UNITED STATES PATENT AND TRADEMARK OFFICE

APPLICATION NO.	FILING DATE	FIRST NAMED INVENTOR	ATTORNEY DOCKET NO.	CONFIRMATION NO.
10/771,871	02/04/2004	Joseph W. Pieczynski II	2108.003600	3761
45488 7590 03/30/2007 WILLIAMS, MORGAN & AMERSON 10333 RICHMOND, SUITE 1100 HOUSTON, TX 77042			EXAMINER WOODALL, NICHOLAS W	
			ART UNIT 3733	PAPER NUMBER
SHORTENED STATUTORY PERIOD OF RESPONSE			MAIL DATE	DELIVERY MODE
3 MONTHS			03/30/2007	PAPER

Office Action Summary

Figure 1

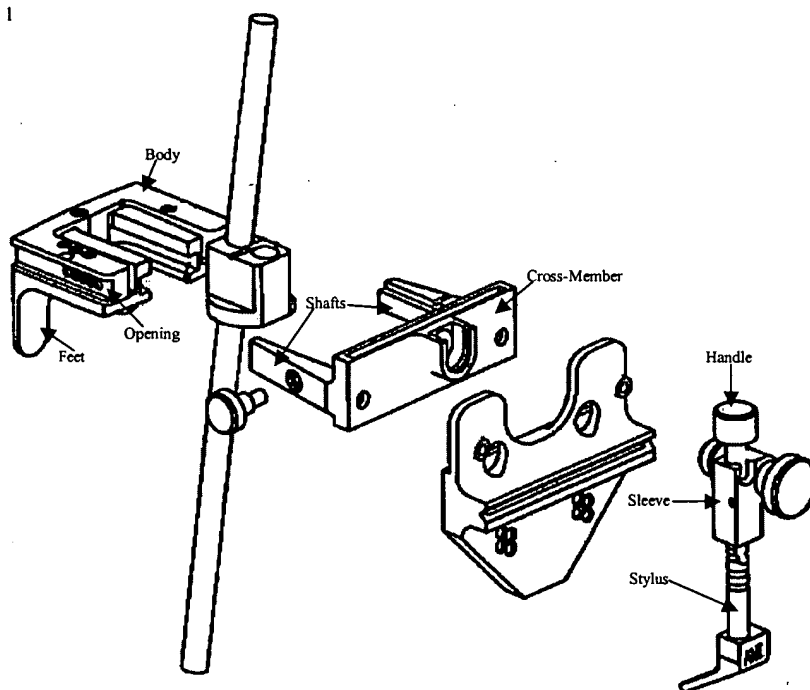
reference a sleeve. Regarding claim 27, Burkinshaw discloses a device comprising a body having a bottom surface, a stylus with a tip, and a sleeve capable of moving the tip of the stylus in a direction that is approximately perpendicular to a plane containing the bottom surface of the body of the device. Regarding claim 28, the applicant invoked U.S.C. 112 6th paragraph with a "means for" limitation in the claim. The examiner is required to reference the specification for the corresponding structure performing the function in the claim. The examiner believes the "means for" limitation is referenced in the specification on page 23 lines 8-14 regarding a cradle assembly. Therefore, the examiner will understand the "means for" language of claim 28 to reference a cradle assembly. Regarding claim 28, Burkinshaw discloses a device further comprising a cradle assembly capable of moving the tip of the stylus in a direction that is approximately parallel to a plane containing the bottom surface of the body. Regarding claim 29, Burkinshaw discloses a device wherein the body further comprises a plurality of protruding feet. Regarding claim 30, the applicant does not invoke U.S.C. 112 6th paragraph with the "means for" limitation in the claim because the claim does not meet the criteria of the three-prong analysis because the applicant modifies the "means for" phrase with sufficient structure for achieving the function. Regarding claim 30, Burkinshaw discloses a device comprising a sleeve that is capable of having a stylus positioned within, a sleeve having an axis that is approximately perpendicular to a plane containing the bottom surface of the body, and a handle coupled to the stylus. Regarding claim 31, the applicant does not invoke U.S.C. 112 6th paragraph with the "means for" limitation in the claim because the claim does not meet the criteria of the

three-prong analysis because the applicant modifies the “means for” phrase with sufficient structure for achieving the function. Regarding claim 31, Burkinshaw discloses a device comprising a cradle assembly, wherein the cradle assembly includes a cross-member operatively coupled to the stylus and a plurality of shafts coupled to the cross-member and capable of being slidably positioned within openings formed in the body of the device. Regarding claim 49, Burkinshaw discloses a device that can inherently be used by a method comprising the steps of making an incision in a patient's knee, attaching a femoral implant sizing guide to a prepared surface of a femur of the patient, wherein the sizing guide has a body with a bottom surface and a moveable stylus with a tip, after said sizing guide is attached to the femur, moving the tip of the stylus in both a direction that is approximately perpendicular to a plane containing the bottom surface and in a direction that is approximately parallel to a plane containing the bottom surface to position the tip of the stylus at a location proximate an anterior cortex region of the femur, and determining the size of a femoral knee prosthesis to be positioned on the femur. Regarding claim 50, the device used in Burkinshaw is used in part of a total knee arthroplasty, wherein the femur is prepared to receive a femoral reconstruction component or knee implant. Therefore the examiner believes Burkinshaw discloses a device that can be inherently used by a method as discussed above further including the step of attaching a femoral prosthesis of the determined size onto the femur, since the device is preparing the femur to receive such an implant. Regarding claim 51, Burkinshaw discloses a device that can inherently be used by a method as discussed above further comprising the step of rotating the tip of the stylus. Regarding claim 53,
